SERVICE BULLETIN

N° 139-514

REV.: A March 16, 2023

ATA 52 - INSTALLATION OF KIT SAR PROTECTION STEP

Figure 1

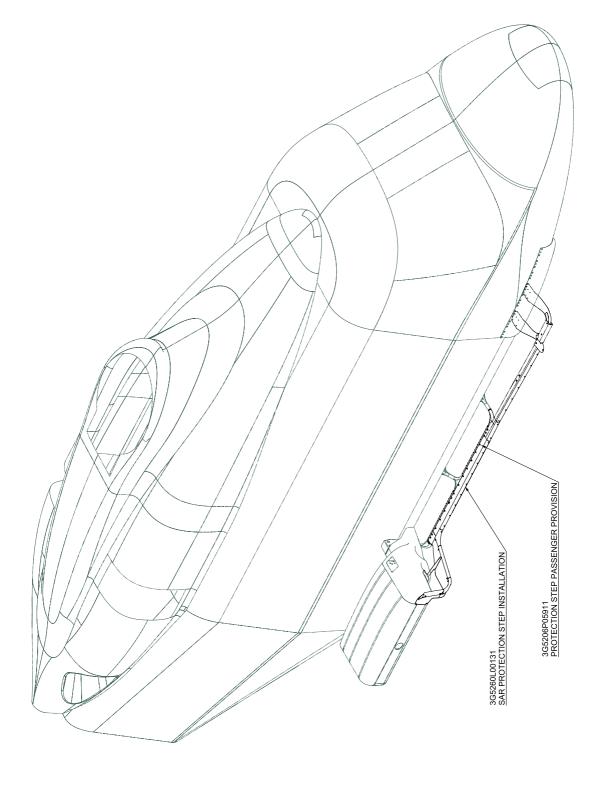
- 3. With reference to Figures 1 and 2, perform the installation of the RH passengers step protection provision P/N 3G5206P05911 as described in the following procedure:

- 1. In accordance with AMP DM 39-A-00-20-00-00A-120A-A prepare the helicopter on ground for a safe maintenance. Disconnect the battery, all electrical power sources and/or the external power supply.
- 2. With reference to Figure 1 and to Figures 3 thru 5, perform the SAR protection step P/N 3G5260L00131 installation, as described in following steps.
- 3. With reference to Figure 4 Detail C, remove and discard the n°2 screws P/N AN525-10R10 and the n°2 washers P/N NAS1149C0316R under the RH sponson.
- 4. With reference to Figure 4 Detail C, remove and discard the n°2 screws P/N AN525-10R8 and the n°2 washers P/N NAS1149C0316R on the right side of the RH sponson.

Figure 2

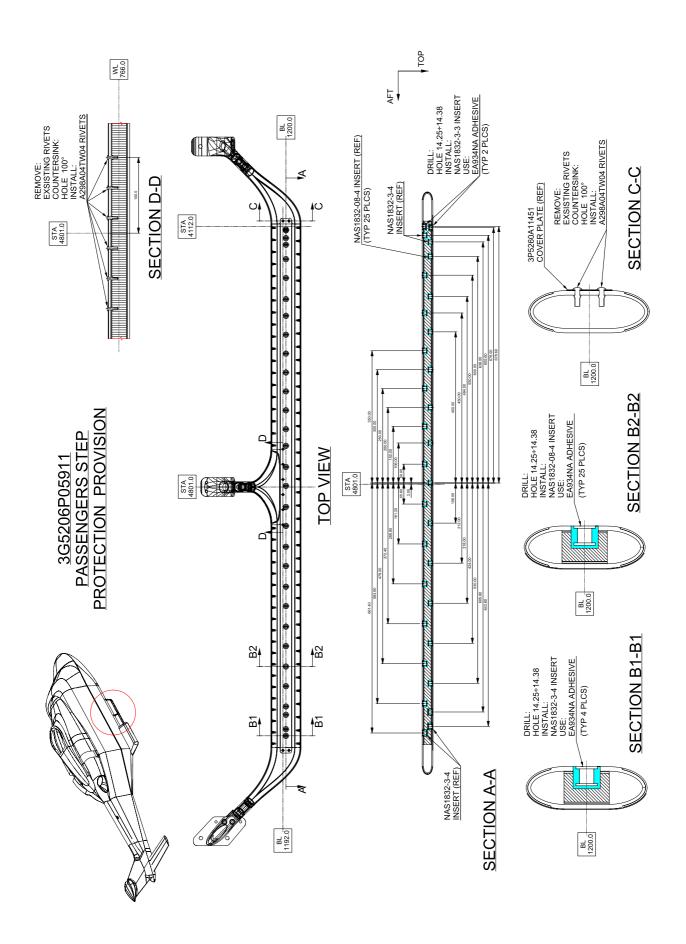
Existing inserts position is allowed if they are at a maximum distance of 32 mm from the ones shown in Figure 2 (on both upper and lower side).

No deviation from the figure is allowed for:

- First three inserts from the forward edge on upper side;
- First two inserts from the aft edge on upper side;
- First two inserts from the forward edge on lower side.

- Additional existing inserts (with respect to those shown in Figure 2) must be closed with adequate screws and adhesive (C057).
- There are not missing inserts with respect to those shown in Figure 2.

- 3.1 With reference to Figure 2 Section D-D, carefully drill out from the passenger footstep n°6 existing rivets P/N AS46789-409. Countersink holes 100°, Ø 6.0.

- 3.2 With reference to Figure 2 Section D-D, install n°6 blind titanium rivets P/N A298A04TW04.
 - 3.3 With reference to Figure 2 Section C-C, carefully drill out, from the passenger footstep n°2 existing rivets P/N AS46789-409. Countersink holes 100°, Ø 6.0.

- 3.4 With reference to Figure 2 Section C-C, install n°2 blind titanium rivets P/N A298A04TW04.
- 3.5 With reference to Figure 2 Section A-A, mark on upper side and lower side footstep cover plates n°31 positions of the blind threaded inserts to be installed.

- 3.6 With reference to Figure 2 Section A-A, carefully drill n°31 holes of Ø 14.25÷14.38 in the upper and lower cover plate skin. Hole depth must be 0.5 mm deeper than insert height.

- 3.7 In accordance with CSRP DM CSRP-A-51-42-00-00A-720A-D and with reference to Figure 2 Section A-A install the threaded inserts, using adhesive EA934NA:

Figure 3

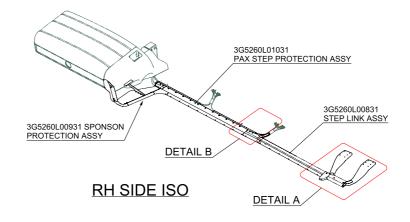
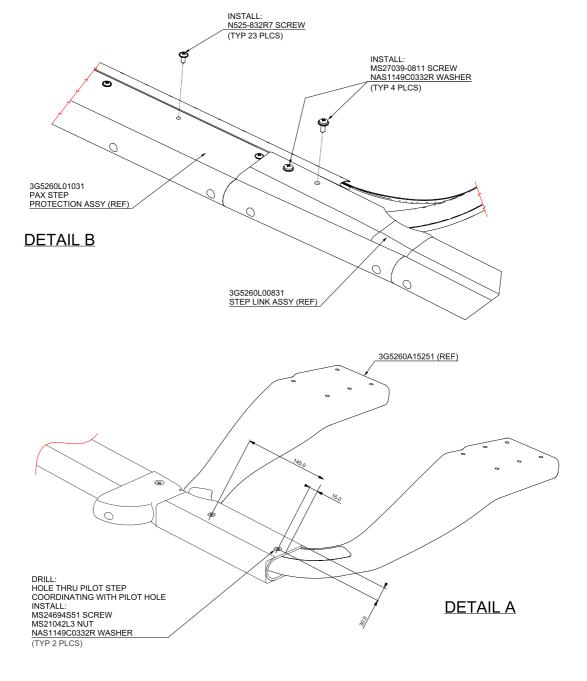
- n°2 machine screws P/N MS27039-1-07, n°2 flat washers P/N NAS1149C0332R:
 - n°2 machine screws P/N AN525-832R7.
- 5.3 With reference to Figure 3 Detail B, position the pax step protection assy P/N 3G5260L01031A1 on the RH passenger fixed footstep by aligning it with the sponson protection body P/N 3G5260L00551 installed in the step 5.2 and perform the following procedure:

- n°1 nut P/N MS21069-L08;
 - n°1 rivet P/N MS20426AD3;
 - n°1 flat washer NAS1149DN832K;
 - n°1 screw P/N MS27039-0811;
- 5.4 With reference to Figure 3 Detail B, install the pax step protection assy P/N 3G5260L01031A1 on the RH passenger fixed footstep by means of n°23 machine screws P/N AN525-832R7.

- n°2 machine screws P/N MS27039-1-07, n°2 flat washers P/N NAS1149C0332R;
 - n°2 machine screws P/N AN525-832R7.
- 7. With reference to Figure 1 and Figure 3 Detail B, position the pax step protection assy P/N 3G5260L01031 on the RH passenger fixed footstep and align it with the sponson protection assy P/N 3G5260L00931 installed in the step 6.

- 8.1 With reference to Figure 3 Detail B, according to the position of inserts on the RH passenger fixed footstep, drill the rear upper side and the rear lower side of the step link assy P/N 3G5260L00831.
- 8.2 With reference to Figure 3 Detail A, according to the indicated distances, drill respectively the upper side of the step link assy P/N 3G5260L00831 and the pilot step P/N 3G5260A15251.
- 8.3 With reference to Figure 3 Detail B install the step link assy P/N 3G5260L00831 on the RH passenger fixed footstep by means of:
 - n°4 flat washers P/N NAS1149C0332R;
 - n°4 machine screws P/N MS27039-1-07.
- 8.4 With reference to Figure 3 Detail A install the step link assy P/N 3G5260L00831 on the pilot step by means of:
 - n°2 flat washer P/N NAS1149C0332R;
 - n°2 machine screws P/N MS24694S51;
 - n°2 self-locking nuts hexagon extended washer P/N MS21042L3.

Figure 4

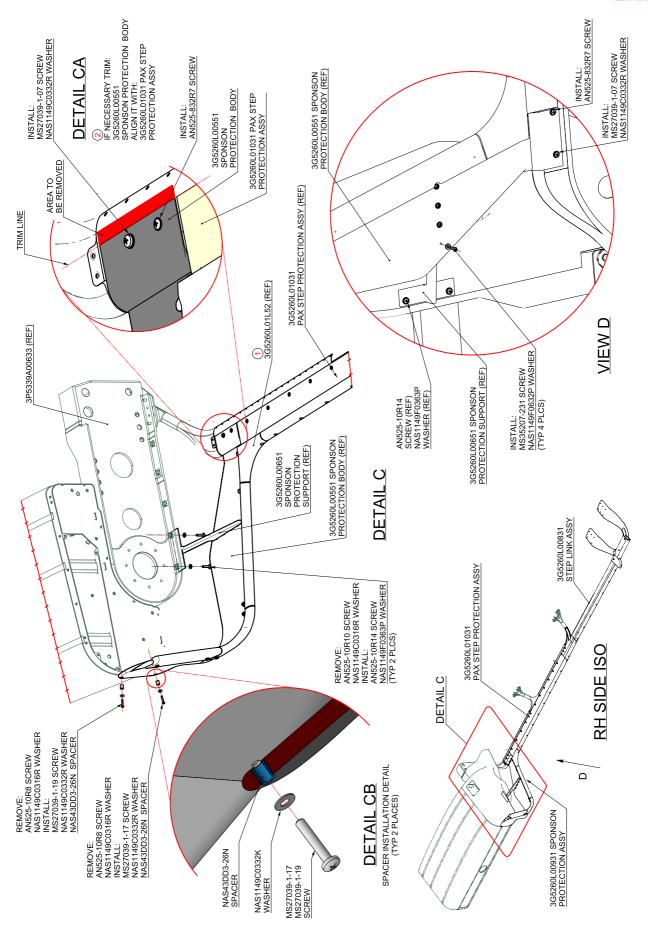
- 5.1 With reference to Figure 4, perform the sponson protection support P/N 3G5260L00651 installation, as described in the following procedure:
 - 5.1.1 With reference to Figure 4 Detail C, drill the sponson protection support P/N 3G5260L00651 according to the n°2 inserts positions installed under the RH sponson.

- 5.1.2 With reference to Figure 4 Detail C, fix the sponson protection support P/N 3G5260L00651 in the lower side of the RH sponson by means of:
 - n°2 flat washers P/N NAS1149F0363P;

- 5.2.1 With reference to Figure 4 Detail CA and View D, drill the sponson protection body P/N 3G5260L00551 according to the n°4 inserts

If positioning the sponson protection body P/N 3G5260L00551, it is not in line with the pax step protection assy P/N 3G5260L01031A1, it is allowed to trim the body to align it to the pax step protection assy, in accordance with Figure 4, Detail CA, POSITION 2.

- 5.2.4 With reference to Figure 4 Detail C and Detail CB, fix the sponson protection body P/N 3G5260L00551 in the RH side of the RH sponson by means of:

- 5.2.5 With reference to Figure 4 View D, fix the sponson protection body P/N 3G5260L00551 to the sponson protection support P/N 3G5260L00651 by means of:

- n°4 flat washers P/N NAS1149FN632P;
 - n°4 machine screws P/N MS35207-231.
- 5.2.6 With reference to Figure 4 Detail CA and View D, fix the sponson protection body P/N 3G5260L00551 to the RH rear side passengers fixed footstep by means of:

- 5.3.3 With reference to Figure 4 POSITION 1, fix the sponson protection corner P/N 3G5260L01252 on the pax step protection assy P/N 3G5260L01031A1 by means of

- 6. With reference to Figures 3 thru 5, install the protection assy P/N 3G5260L00931 as described in the following procedure:
 - 6.1 With reference to Figure 4, drill the sponson protection assy P/N 3G5260L00931 according to:

- 6.2 With reference to Figure 4 Detail C, fix the sponson protection assy P/N 3G5260L00931 in the lower side of the RH sponson by means of:
 - n°2 flat washers P/N NAS1149F0363P;

- 6.4 With reference to Figure 4 Detail CA and View D, fix the sponson protection assy P/N 3G5260L00931 to the RH rear side passengers fixed footstep by means of:

Figure 5

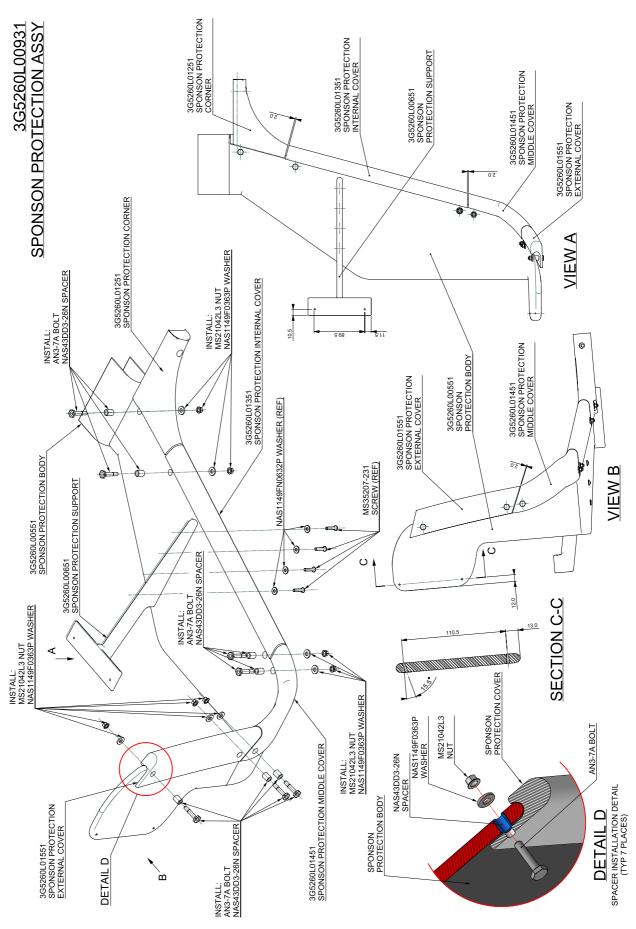
- 5.5 With reference to Figure 5 perform the installation of the sponson protection corner P/N 3G5260L01252, of the sponson protection internal cover P/N 3G5260L01351, of the sponson protection middle cover P/N 3G5260L01451 and of the sponson protection external cover P/N 3G5260L01551 on the sponson protection body P/N 3G5260L00551 as described in the following procedure:

- 5.5.2 With reference to Figure 5, fix all the covers on the sponson protection body P/N 3G5260L00551 by means of:
